FINAL Environmental Impact Statement Newmont Mining Corporation's South Operations Area Project Amendment

Appendix E Public Comment Letters and Responses

RESPONSES TO PUBLIC COMMENTS ON SOAPA DEIS

Figure 1: Flow increases from the Maggie Creek canyon to the confluence with the Humboldt River. The hydrograph was determined taking the difference between recorded flows at USGS gaging stations.

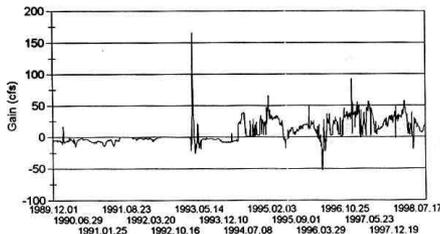
to dewatering discharge, Maggie Creek lost 3.2 cfs from the canyon to the Humboldt River (Figure 1). With dewatering, it gains 19.8 cfs (Figure 1). These losses are averages calculated without removing the spikes caused by obvious local storm inflows. The total contribution of Newmont to the discharge into the Humboldt River between April 25, 1994 and September 30, 1998 is 23 cfs (actually a little less due to several isolated flood inflows).

Figure 1: Computed head levels with time for the 15 layers.

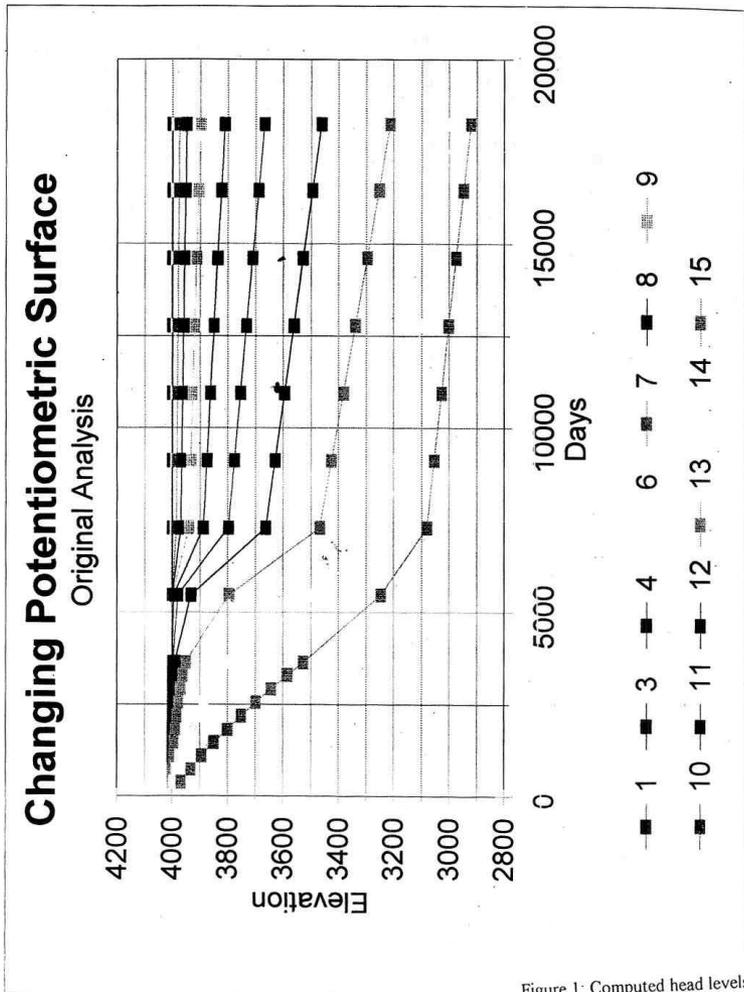
Figure 1 shows the changing potentiometric surface in most layers. Clearly, the lower layer, with $K=10$ ft/d, depressurizes quickly and almost reaches 2900' by the end of the scenario. This reflects the expanding dewatering cone into the bedrock beneath the Carlin formation. The lower clay layers also draw down substantially, but the upper layers barely change at all. The upper layer 4 actually increases initially as recharge infiltrates into it before lowering to only 3999 (Figure 2). There is only a one-foot drawdown in the uppermost clay layer after 61 years of stress. The top layer shows a modest (less than 0.5 foot) increase in head due to mounding recharge.

Figure 3: Various model fluxes with time.

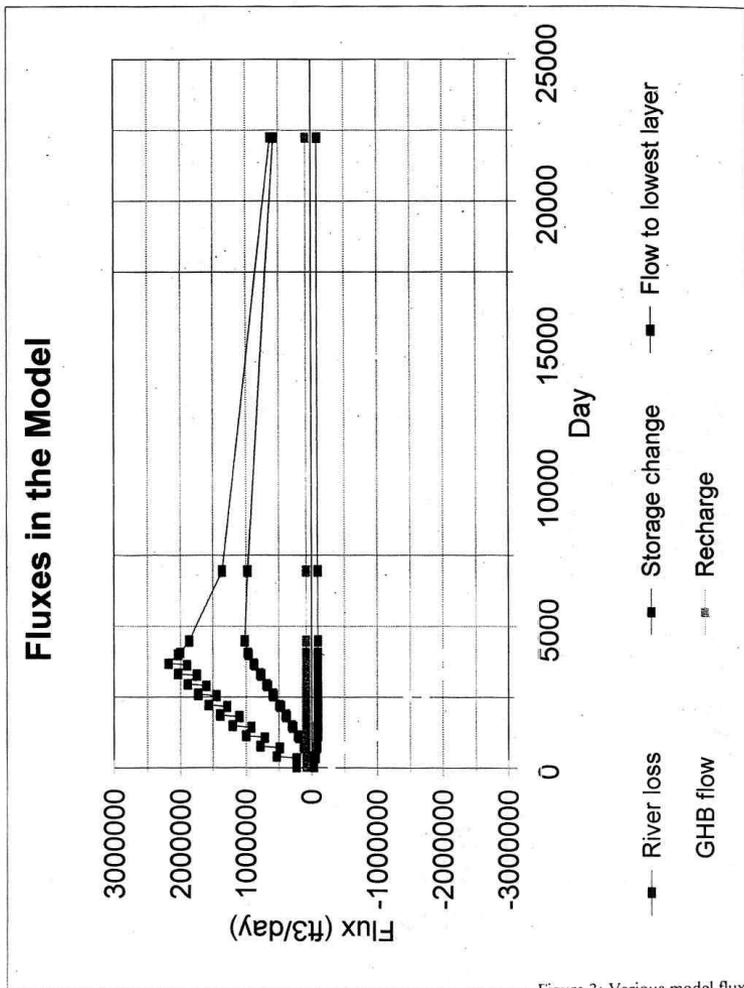
Because there is no drawdown in the upper layers there is no change in flux to the river (Figure 3). The GHB flux increases to 1,000,000 ft³/day after 4500 days. This is the time that the GHB reaches the maximum depth. After that, the flux decreases as the cone expands and the gradient at the GHB decreases. Total recharge equals about 89,000 ft³/day; flux to the river fluctuates around this value. Recharge does not go to satisfying the GHB demand.

Storage releases satisfy most of the GHB demand which almost mirrors the GHB flows (Figure 3). Initially, most the storage release is in the lower layer but eventually flow to layer 15 equals about half of the GHB flux at the point where maximum stress is reached. As indicated by the increase in flow to the lower layer by the end of the model run, most GHB flux is from upper layers (Figure 3). Based on the fact that recharge just cycles to the river, this is mostly releases from the clay layers. This is also reflected in the changes occurring in the potentiometric surface of the lower clay layers.

Figure 4: Effects of increasing the conductivity of the clay by amounts shown in the legend on the flow to the GHB

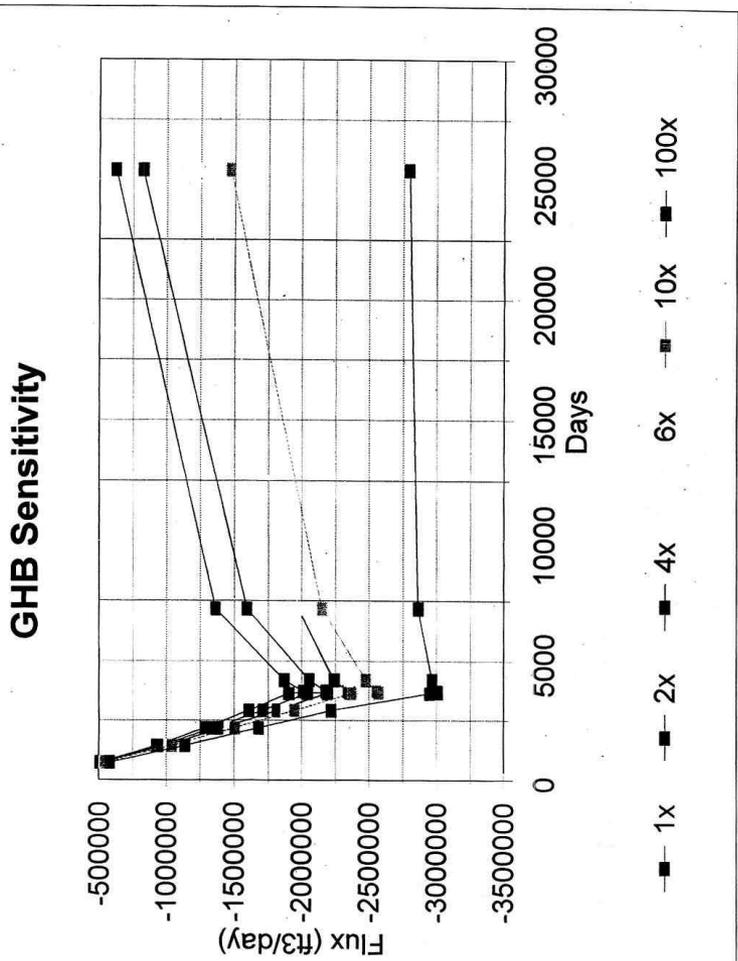
Increasing the clay layer conductivity increases the GHB flux (Figure 4). At the point that the maximum stress (GHB reaches 2900' after 11 years) begins the range in flux is only about 1,100,000 ft³/day. The flux decreases quicker for low conductivity values. Flux remains higher than 2,750,000 ft³/d for the 100xKh value analysis. The tendency to higher fluxes as clay layer conductivity increases drives increased flow through the layers (Figure 5). After the complete 61 year run, a steady flux of 2,800,000 ft³/d was occurring through all layers for the 100*Kh scenario. For the other scenarios, the vertical flux was still becoming established. None of the upper layers had established vertical flux in excess of recharge by 61 years; flux for the original condition was essentially 0. This indicates that many years could pass before dewatering of the lower layer affects the upper layer. More importantly, only a two orders of magnitude change will cause a complete change in vertical flux over a 61 year period.

Figure 6: Change in total model storage for changes in clay layer conductivity as shown in the legend.

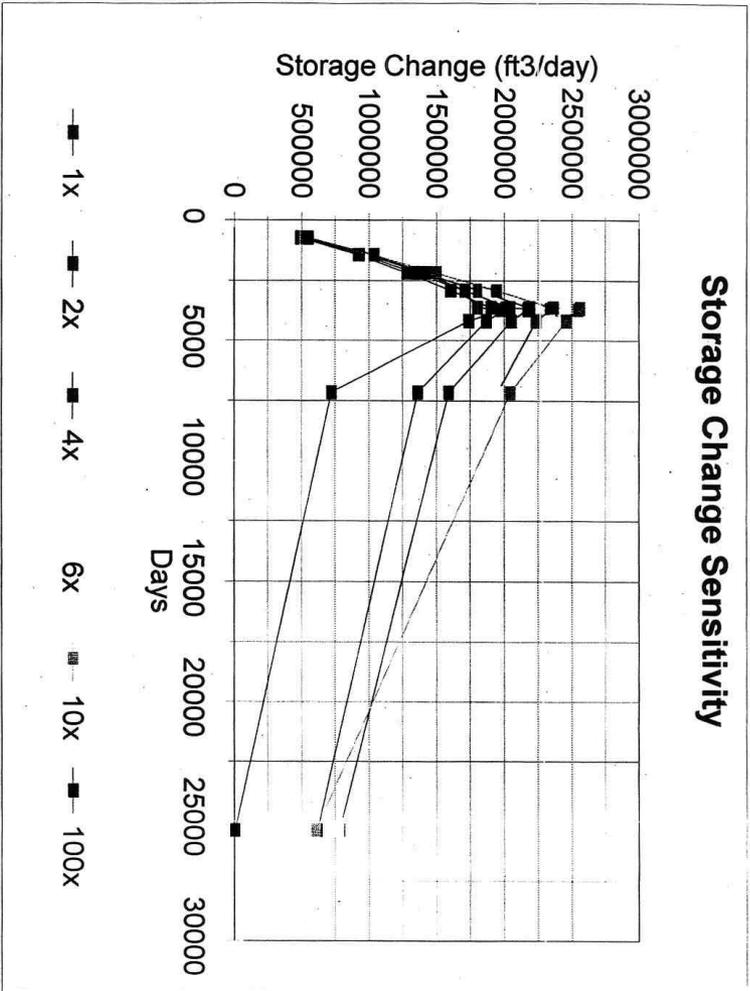
Releases from storage are more complicated (Figure 6). With clay layer conductivity increasing to 10*Kh, initial storage releases increase from 1,600,000 to 2,500,000 ft³/d after 11 years. For the 100*Kh scenario, storage releases are initially high, but rapidly drop. This reflects the propagation of a gradient through the layers and the contribution of recharge to the vertical flux between layers. Thus, the amount of

Figure 7: Change in river flux for changes in clay layer conductivity as shown in the legend.

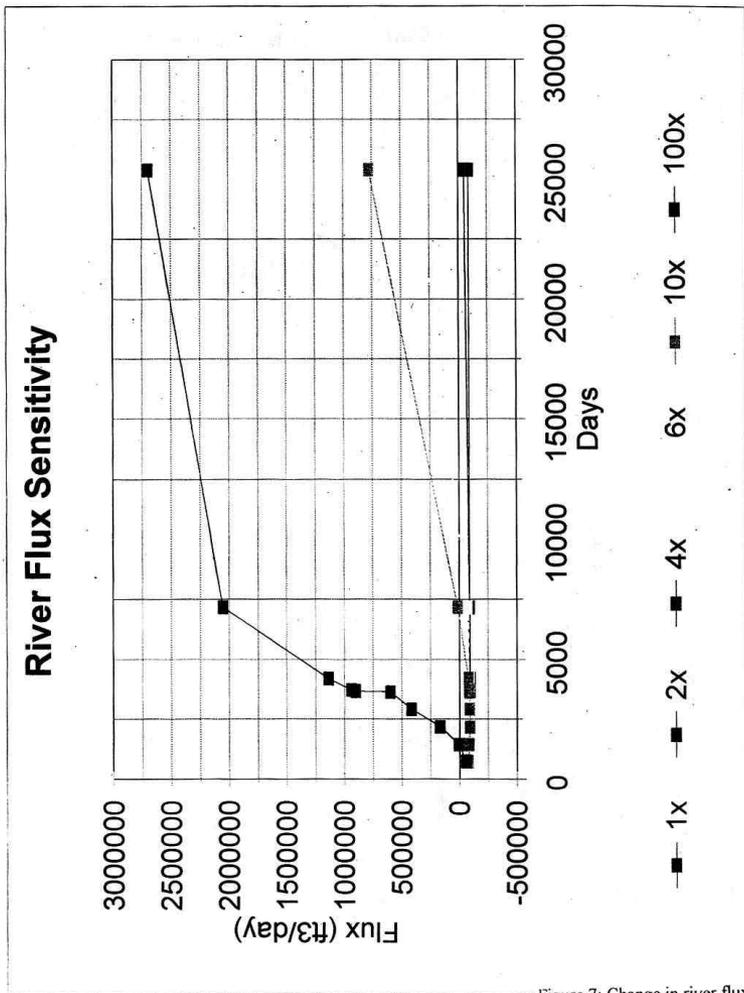
water released from storage decreases as the vertical gradient allows water to be drawn from the river (Figure 7).

River flux is much higher for $10\times$ and $100\times$ K_h , but even the $2\times K_h$ scenario causes substantial changes to the river flux (Figure 7). Only for the original K_h , 0.00001 ft/d, does river flux remain unchanged. More than 7000 days (19 years) are required until a breakthrough occurs where impacts to the river occur for all scenarios up to $10\times$ K_h .

Figure 8: Change in flow to layer 15 for changes in clay layer conductivity as shown in the legend.

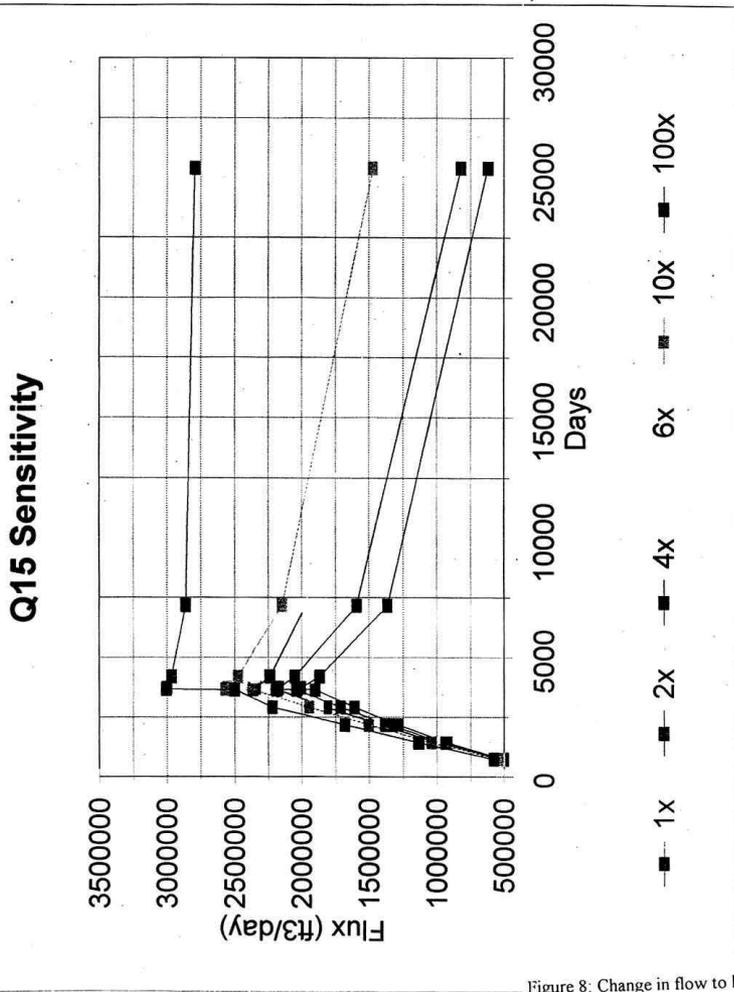
Flow into the lower layer peaks at the time that the maximum stress is applied and begins to fall thereafter (Figure 8). The rate of fall is highest for the original conductivity because the drawdown cone expands, the gradient to the GHB decreases and the total flux to the GHB also decreases. There is a sharp increase in vertical flux at the lower layers for the original conductivity at 4209 days (Figure 9). As time advances, flow to the lower layer decreases, but vertical flow begins in higher clay layers.

Figure 24: GHB flux for the original scenario and three gravel in clay layer scenarios.

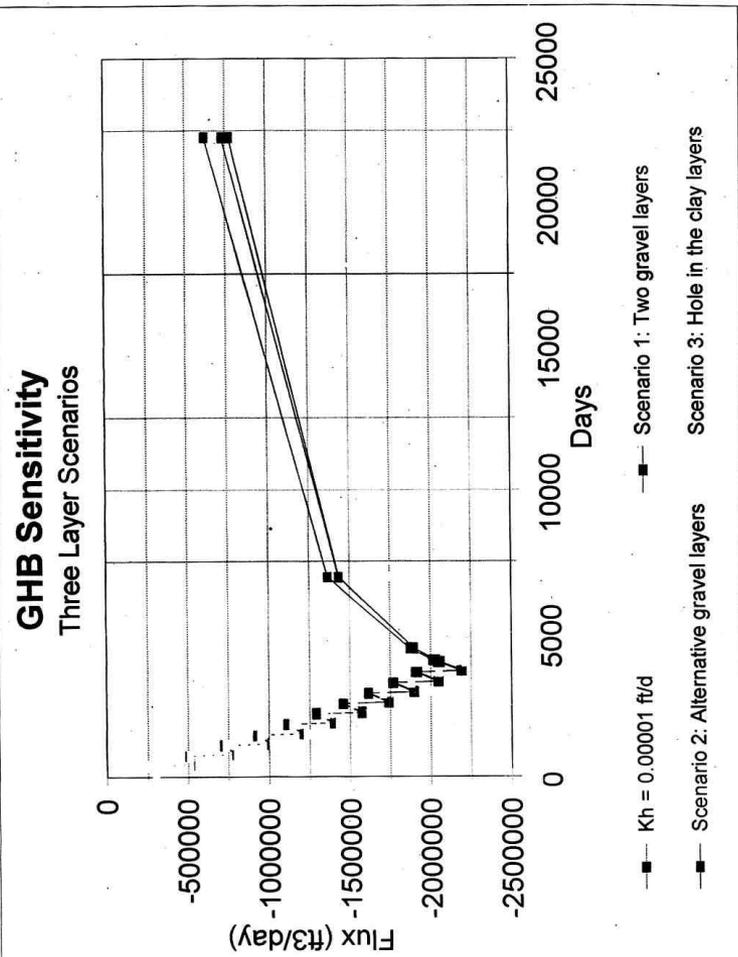
For most of the model run, scenarios 1 and 2 had a less than 5% effect on the flow to the GHB boundary (Figure 24). The lack of difference between scenario 1 and 2 as opposed to both of their differences from the original scenario suggests that the mere presence of gravel in the clay layer increases flow from the system, especially in later years. Scenario 3 almost doubled the flow from the system. However, the "hole" in the clay layer in this scenario is quite large which suggests that this scenario is an upper limit to the impacts of a hole. However, the increased flows (for any scenario) do not really begin until day 4000.

Initially, flow to layer 15 (Figure 26) is about one-half the flow to the GHB (Figure 24). In the long run, scenario 3 has almost reached steady state with flow to layer 15 equaling flow from the system. Flow to layer 15 lags flow from the system in the two gravel layer scenarios by about 25%. The hole allows steady state to be reached sooner with increased flow from upper layers but less drawdown in lower layers.

Figure 27: River flux for the original scenario and three gravel in clay layer scenarios.

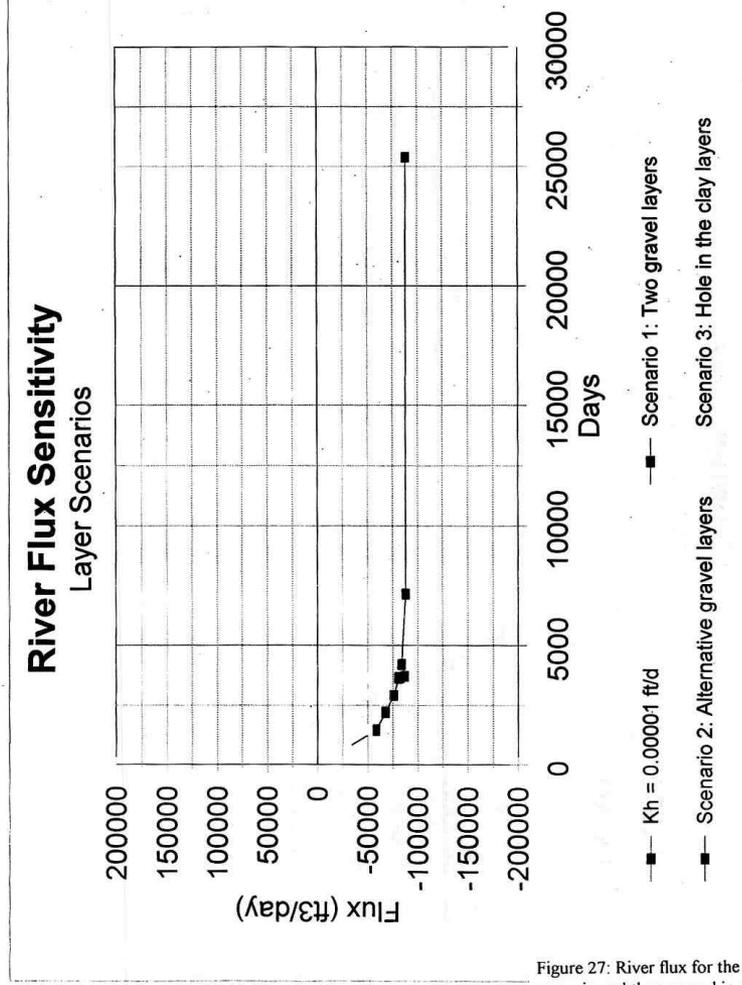
Adding gravel layers to the clay layer had essentially no effect on flux from the river. The increased flow through the hole causes almost a 150,000 ft³/day loss to the river (Figure 27).

Figure 28: Drawdown in layer 1 for the original scenario and three gravel in clay layer scenarios.

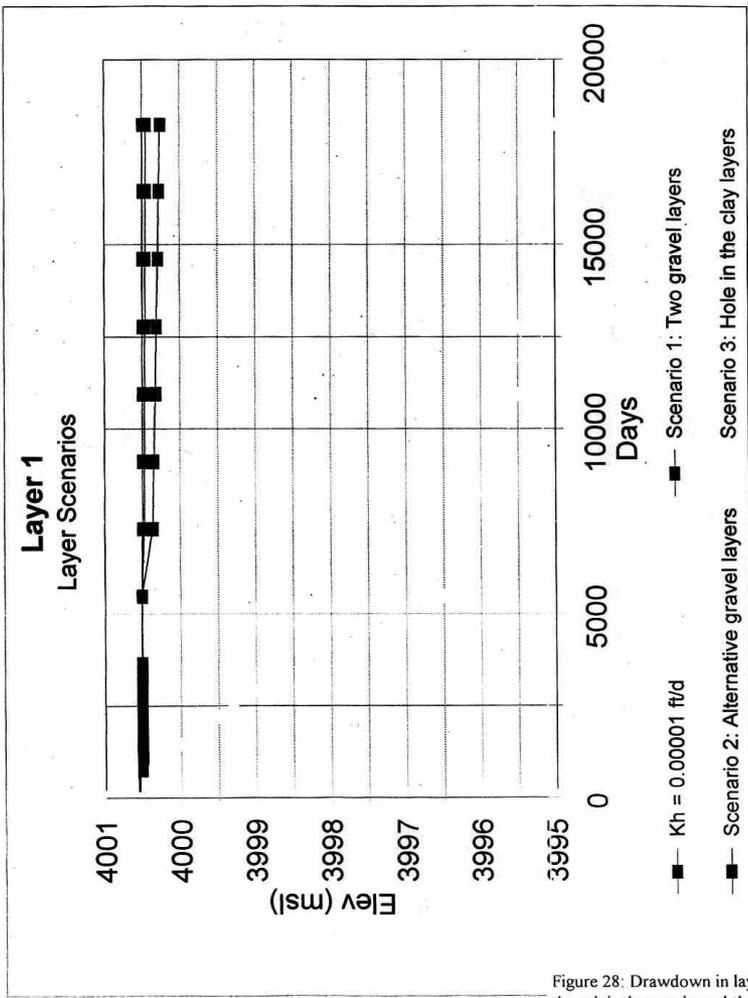
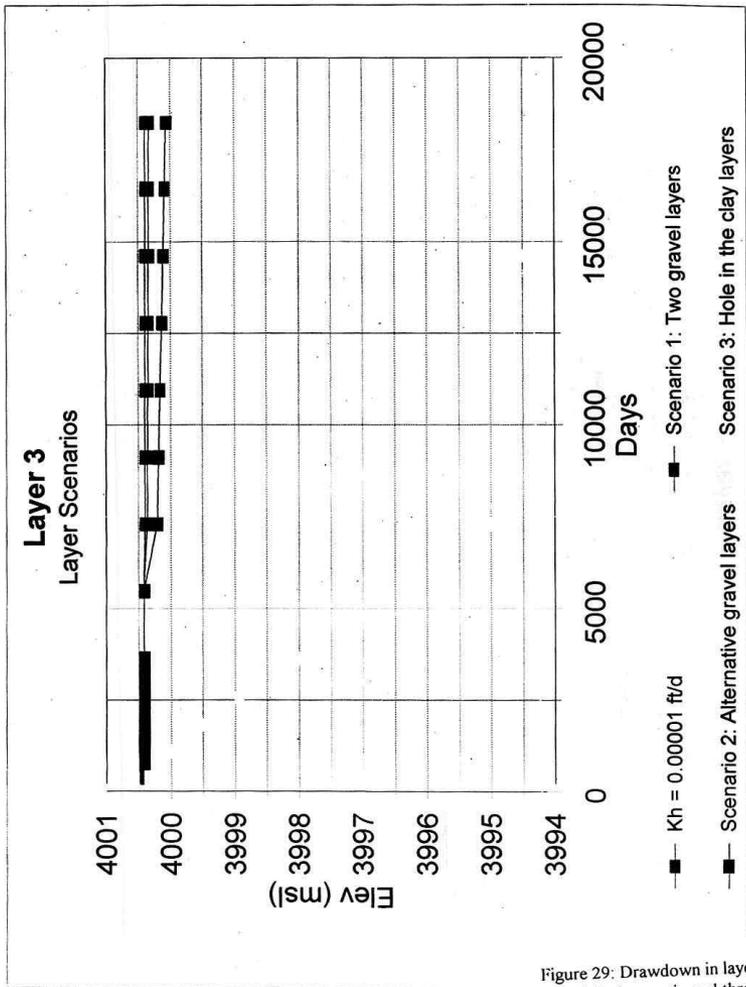
The river flux changes reflect the head changes in layers 1 and 3 (Figures 28 and 29). There was little change from the original caused by adding gravel layers to the clay layer, but the hole allowed the head to drop more than 4 feet. This caused the gradient reversal near the river to change. The head change resembled the effects caused by increasing the hydraulic gradient to $6 \times$ to $10 \times K_h$ in the first sensitivity analysis (Figures 14 and 15).

Figure 30: Drawdown in layer 4 for the original scenario and three gravel in clay layer scenarios.

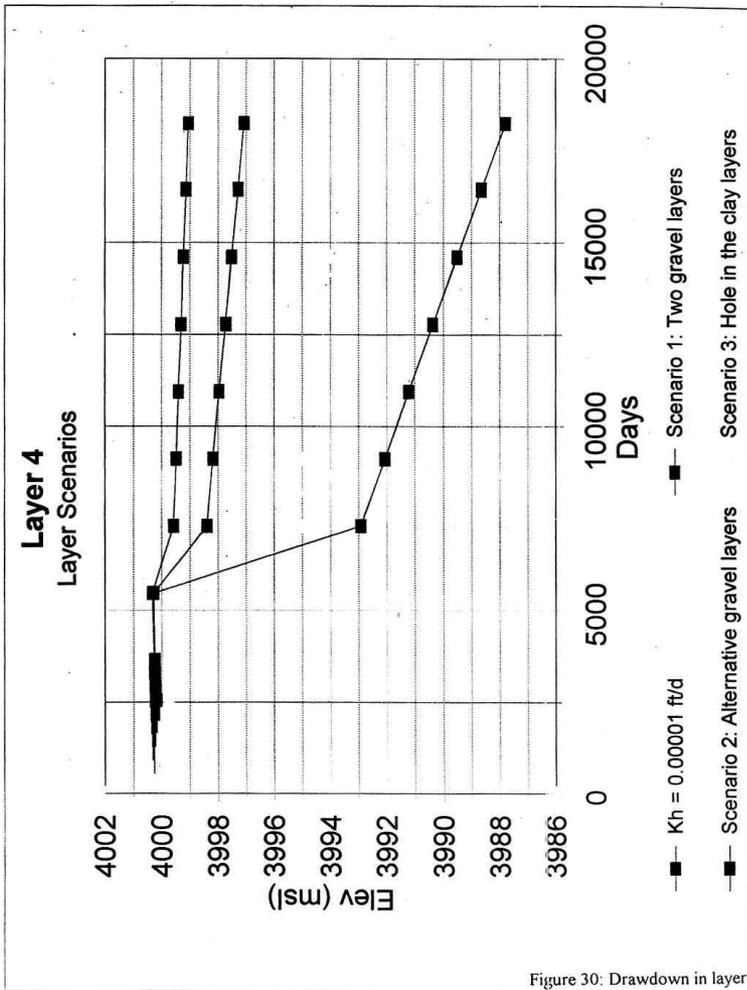
As in the sensitivity analyses changing the clay conductivity, Scenario 3 caused decreased drawdown in the various layers. In layer 4, the drawdown at the target was less than for Scenario 2 (Figure 30). In layers 10 and 14, the Scenario 3 drawdown was even less than for Scenarios 1 and 2. As it becomes easier for water to move through the clay layer, the drawdown due to the mine becomes less.

Figure 34: Groundwater contours for layer 15 for scenario 3 after 61 years.

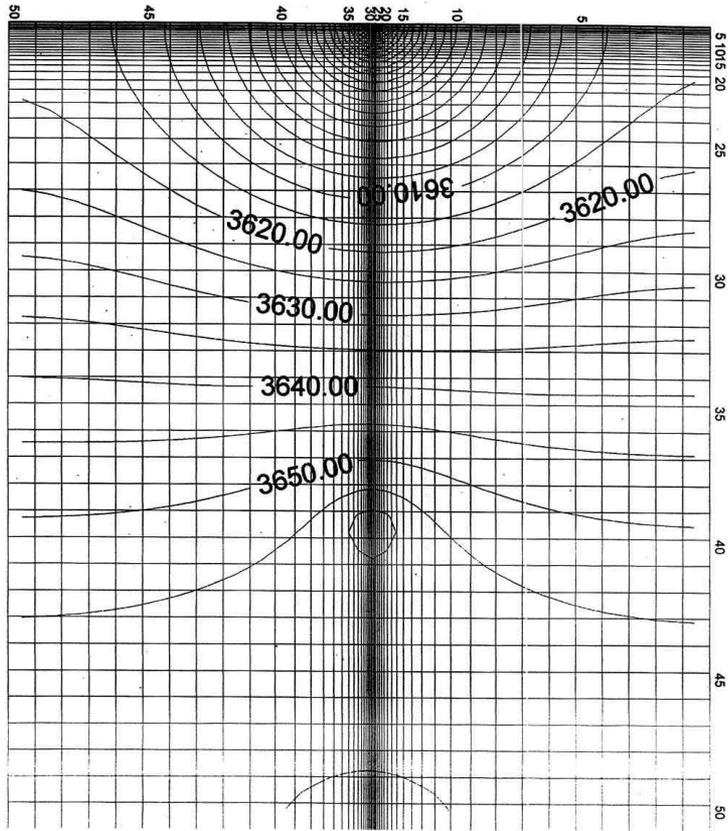
In layer 15 just after the maximum drawdown is reached, contours indicate a relative gradient from 3660 at the hole to 2900 near the GHB (Figure 34). A divide forms between the hole and GHB in layer 14 (Figure 35). Water drains through the layers near the GHB, but more flows through the hole. In layer 14, flow through the hole is 56,400 ft³/d, while flow through the top of the layer is 80300 and through the bottom is 138,000 ft³/d. The difference is due to a 57000 ft³/d release from storage. By layer 13, a slight gradient to the GHB still exists, but the hole causes a massive drawdown (Figure 36). Flow through the hole is 56400 ft³/d while through the top of the layer flow is 61,900 ft³/d and 80,300 ft³/d through the bottom of the layer. Flow through the upper layers and the hole are equal at 55,400 ft³/d.
